Interactive comment on “Calibration of a semi-distributed lumped karst system model and analysis of its sensitivity to climate conditions: the example of the Qachqouch karst spring (Lebanon)” by Emmanuel Dubois et al.

Answer to comments of Anonymous reviewer 2 -2020-06-16

Fig. 1.

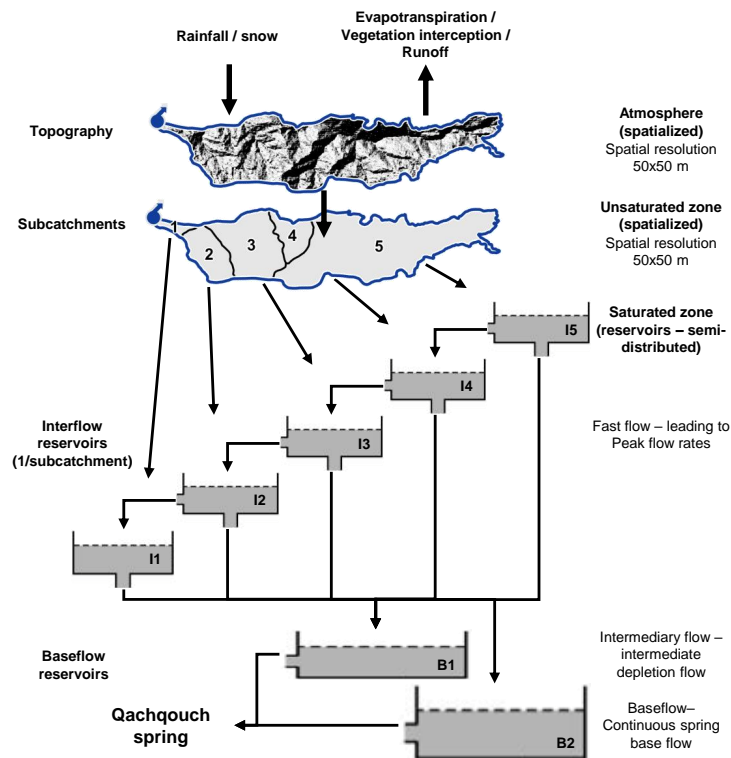
C2: Some clarification of the spatial discretization of the model is necessary. MIKE-SHE is a distributed model, which is here applied fully distributed at the surface but it is operating completely lumped in the subsurface of a set of sub-catchments. Using a sub-catchment approach, this seems to be a semi-distributed application of the MIKESHE model using a fully distributed surface routine, right? A2: That is exact, and we agree that clarification is needed on the spatial discretization of the model. Indeed, only the surface routine is fully distributed (atmosphere and unsaturated zone). Lumped reservoirs are used for the saturated zone (at the subcatchment scale – for the five interflowing reservoirs I1 to I5 in Fig.3) and for the entire system with two base-flow reservoirs for the entire study area (reservoirs B1 and B2 in Fig. 3). In order to clarify this point, Fig. 3 will be modified to add the spatialization details at each level, as follows.

C7: Can you provide a sketch of the conceptual model of the system? A7: We thank the Referee for their suggestion. However, we believe that a conceptual model of the system by itself would be very similar to Fig. 3 and we chose not to add a new figure. However, we will add more details to Fig. 3 to make it clearer and underline in the text that this figure represents a conceptual model of the system. Please refer to A2 for the modified figure and L333-342 will be rephrased: “Although the model adequately reproduces flow discharge, it underestimates the summer low flows. Measurements recorded during flooding of the spring gauging station might be underestimated due to errors in the discharge water level rating curve for high flow rates. Another explanation could be that the fast flow linked to a highly-developed drainage system is oversimplified in this reservoir model (reservoirs I1 to I5 from Fig. 3). The thickness of the UZ, combined with its lithological heterogeneity, as well simplified in the model (Fig. 3), may contribute to the relatively stable summer low flow by allowing considerable water storage, which is represented by the B2 baseflow reservoir in the model (Fig. 3). In fact, the dolostone could be compared to low-permeability porous media drained by a high-permeability system, thus allowing a large storage capacity in the upper parts of the aquifer. Furthermore, the high degree of karstification of the area, resulting from both the eustatic variations (Messinian) and the quaternary glaciations, leads to a complex drainage system, with three identifiable flow components (fast flow, intermediary flow, and baseflow – Fig. 3) and a probable paleo-network under the current base level. This would enhance the storage capacity of the system, as well as induce rapid flow

Additionally, the L67 (Introduction) will be rephrased as follows: “A semi-distributed/lumped model, composed of a spatially distributed superficial and unsaturated zone, and a saturated zone composed of interflowing lumped reservoirs, developed using MIKE SHE (DHI, 2016a, b), is calibrated here using observed spring discharge time series.”
